## Strut Top Mounting

To fit Audi A3 / Sportback (OE ref. 1KO 412 331 B)  
Seat Altea, Toledo (OE ref. 1KO 412 331B)  
Skoda Octavia (OE ref. 1KO 412 331B)  
VW Caddy, Golf 5 / Plus, Touran (OE ref. 1KO 412 331 B)

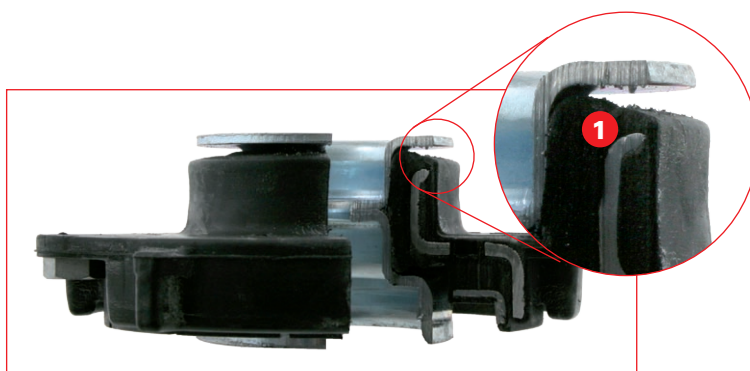
Noise and squeaking from the front axle, even with original VW parts.

These problems are caused by poor manufacturing and use of inferior materials. Mostly, the rubber metal compound dissolves due to insufficient vulcanization. This leads to a high failure rate.

febi bilstein recommends to use the strut top mounting febi 22500 (OE ref. 1KO 412 331 B).

The febi strut top mounting is characterised by the use of high-grade material and professional manufacturing. Material and manufacturing **exceed** the car manufacturers' requirements. febi strut top mountings are also very durable.

The strut top mounting bearing (febi 22498) should also be replaced! The repair kit febi 22502 contains all components which should be replaced, strut top mounting (22500) and ball bearing (22498).
